## **Appendix A - Item 20**

PPL Bell Bend Nuclear Power Plant  
Salem Township, Luzerne County, PA

### ***ACOE Information Requirement:***

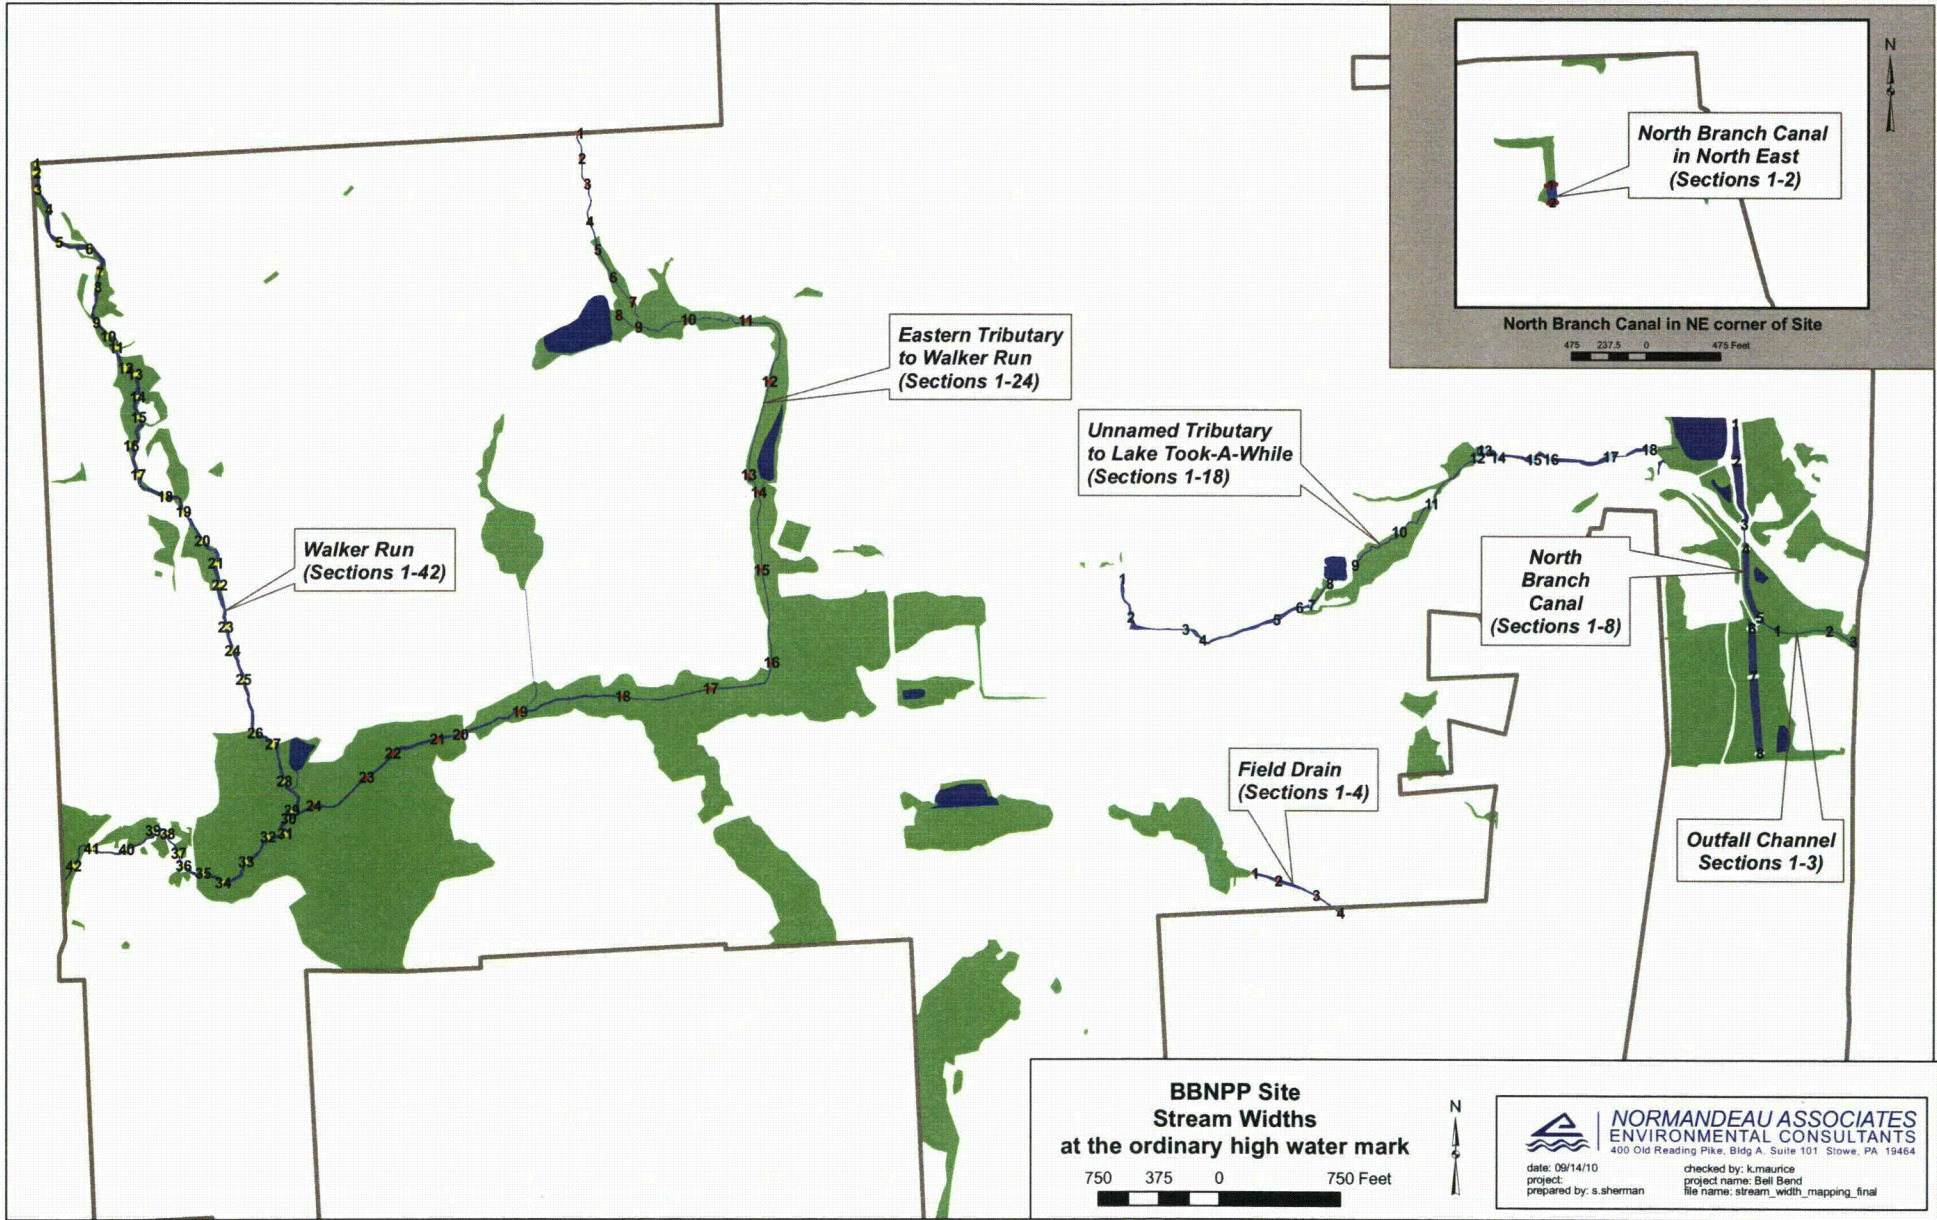
“Indicate the length and average width at the approximate ordinary high water mark of each stream proposed to be impacted. Indicate the total length and area of the stream to be impacted. Indicate the latitude and longitude coordinates of each stream proposed to be impacted at the upstream and downstream proposed impact limits, describe the condition of the stream in the proposed impact area.”

See attached map and table for the length and average width at the approximate ordinary high water mark of each stream with proposed impacts.
